SUBJECT: BHC Waste Site at Diamond Shamrock, Green's Bayou Plant

JOINT WASTE SOURCE SURVEY
OF
GALVESTON BAY AND TRIBUTARIES

Field Report on Diamond Shamrock Corporation
(Greens Bayou Plant)

SUBJECT: Comments on the Diamond
Shamrock Corporation
Greens Bayou Plant, Field
Report; Joint (EPA-TWQB)
Waste Survey; NPDES Appln.:
No. TX-076-0YV-2-000570,
TWQB No. CC749

FIGURE III-7

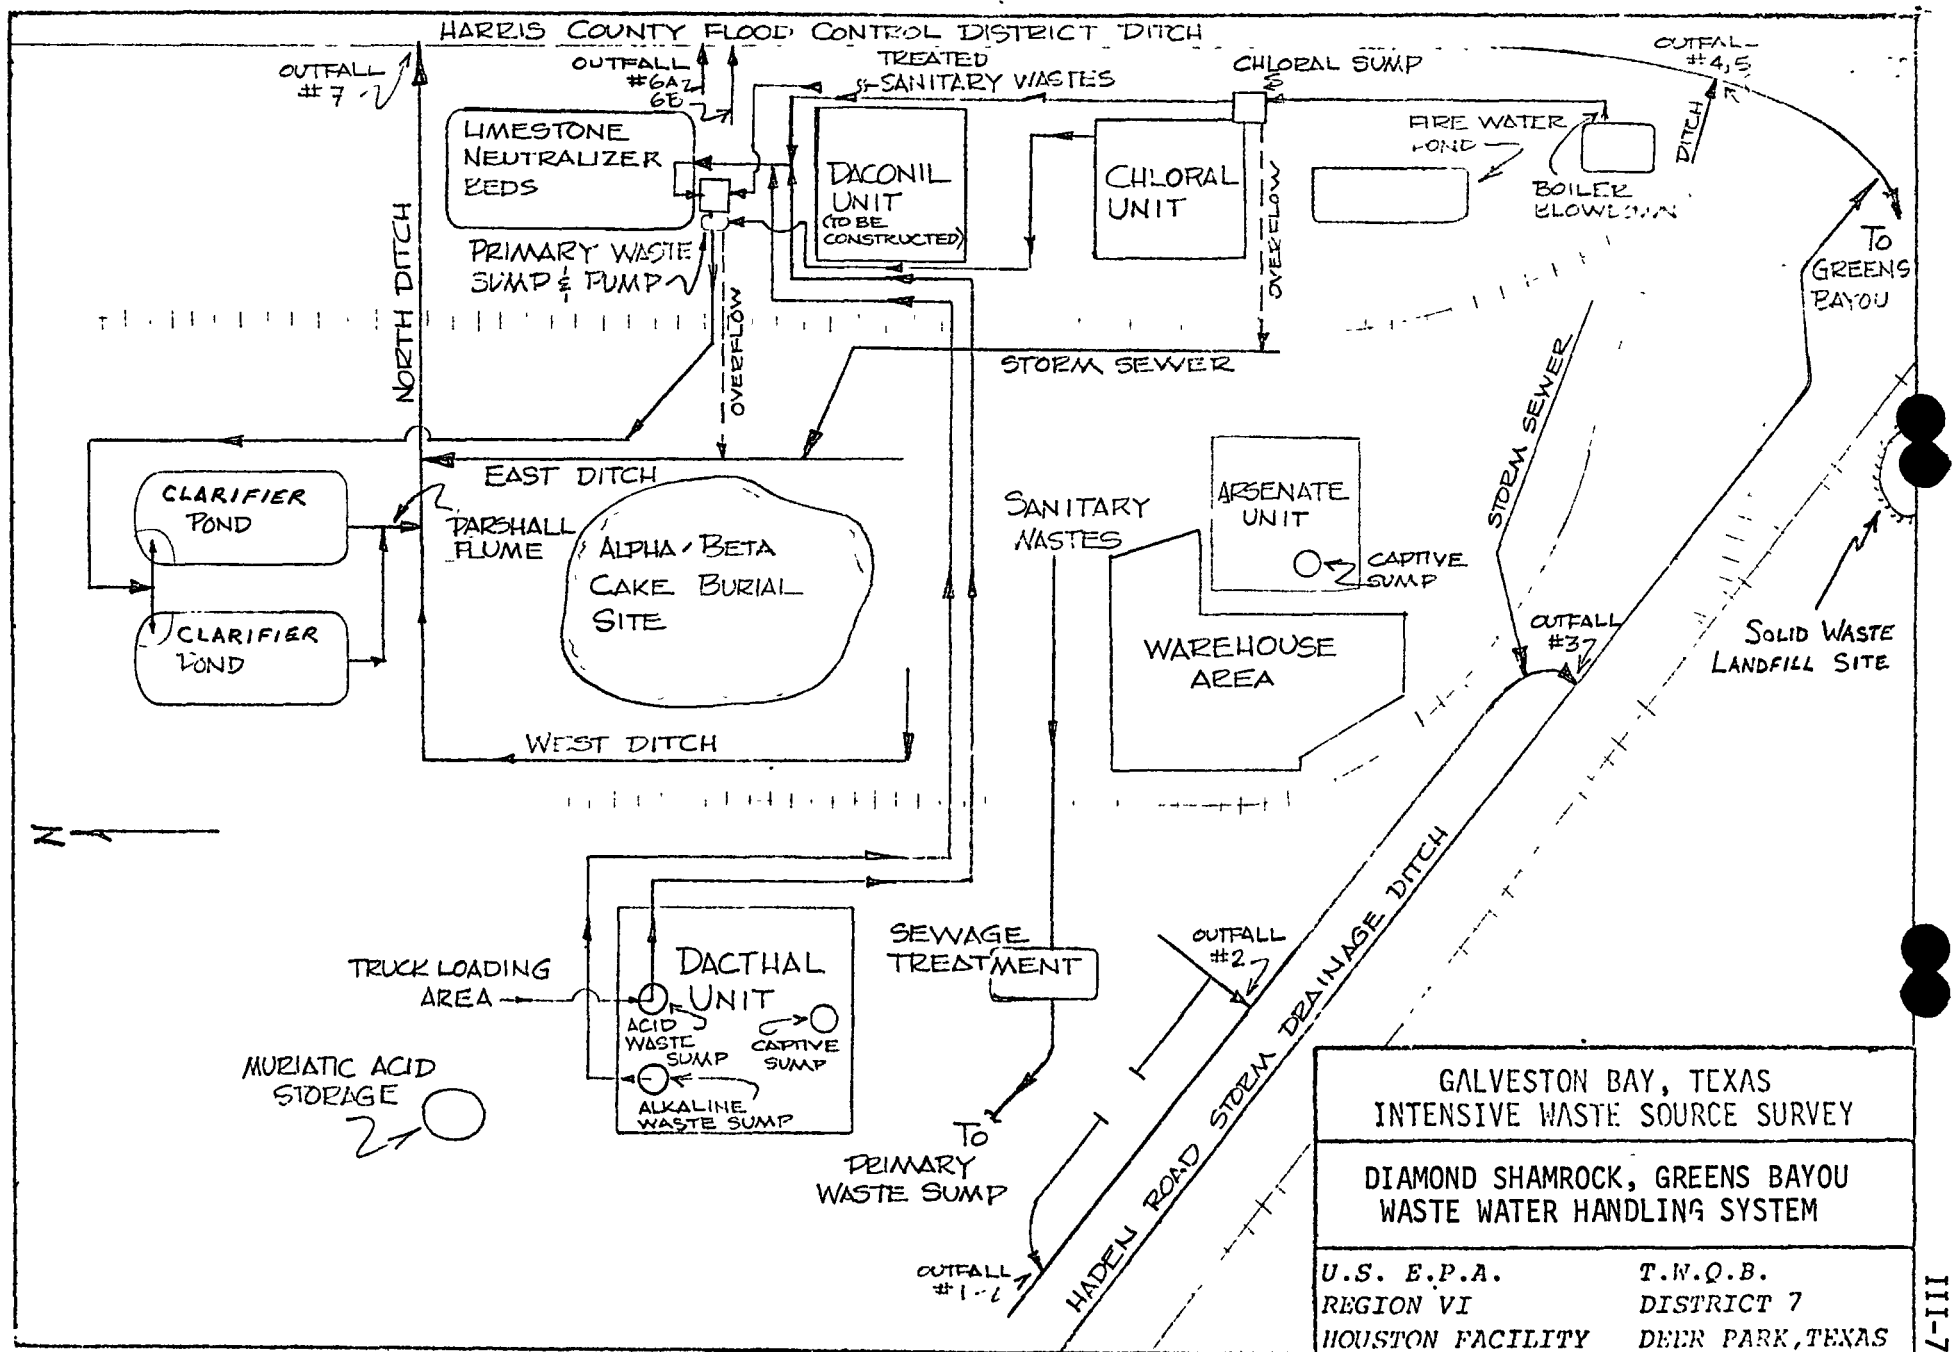
The treatment system is basically comprised of neutralization pits plus two parallel ponds that can be classified as settling - oxidation (natural) lagoons or ponds. These Clarifier Ponds were placed into service during the last half of 1971. Incorporated into the collection system are a series of sumps located at each of the individual process units plus a final, large collection sump located adjacent to the neutralizer pits. Thus most of the process wastewater is handled in force mains up to the time that it empties into the ponds. A sketch of this system was furnished by the plant and a simplified version is included as Figure III-1.

As mentioned previously, there are a series of collection sumps at the various unit locations. The wastes collected in the Chloral and Dacthal units' sumps are pumped to the treatment system. In case of heavy rains or pump failure, the overflow from these sumps can bypass the treatment system. These overflows are collected in the East and West ditches and then flow to the North ditch leading to outfall No. 7.
